**LEGACY PARC
ZONING MAP AMENDMENT 18.683, 18.684,
18.685 AND 18.686 WITH PLANNED REZONING
OVERLAY SITE PLAN 08-30 AND
PROPOSED RESIDENTIAL UNIT
DEVELOPMENT WITH MODIFIED
DEVELOPMENT AGREEMENT
SITE PLAN 08-31**

LEGACY PARC, SITE PLAN NUMBERS 08-30 & 08-31

PLANNING REVIEW

Planned Rezoning Overlay and Residential Unit Development
SP# 08-30 and SP # 08-31/Rezoning 18.683, Rezoning 18.684,
Rezoning 18.685 and Rezoning 18.686

Natural Areas Ranking

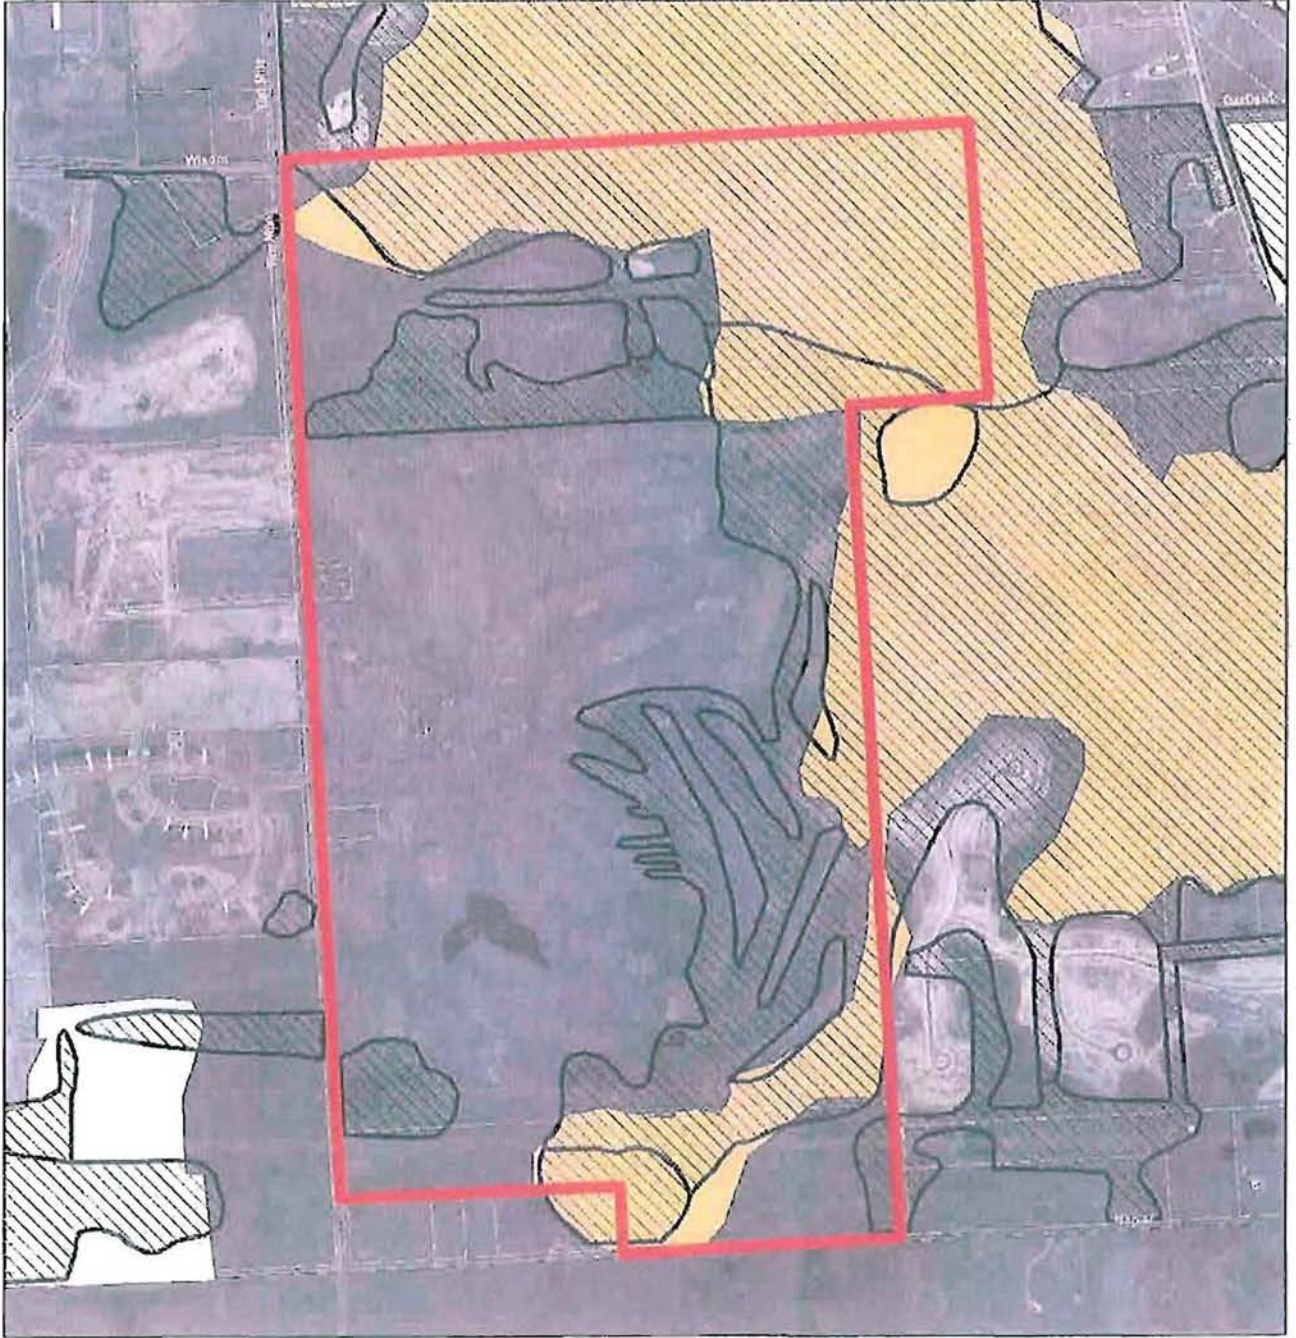
However, the Plan does not quantify the extent of impacts to regulated woodland within MNFI's Priority One Area for conservation. Significant impacts to this quality woodland, rated by MNFI as being the top priority for conservation, are shown graphically on the *Environmental Plan* (Sheet 16) but not quantified. These impacts to the Priority One Area include numerous lots along Brown Jug Circle North and South, lots along Burnley Drive/Normrita Drive/Nucastle Drive, Stormwater Basin D, cul-de-sac lots along Tullymore Court, Stormwater Basin C, lots along Killamey Drive, Stormwater Basin B, and commercial development in the northeast corner of the site.
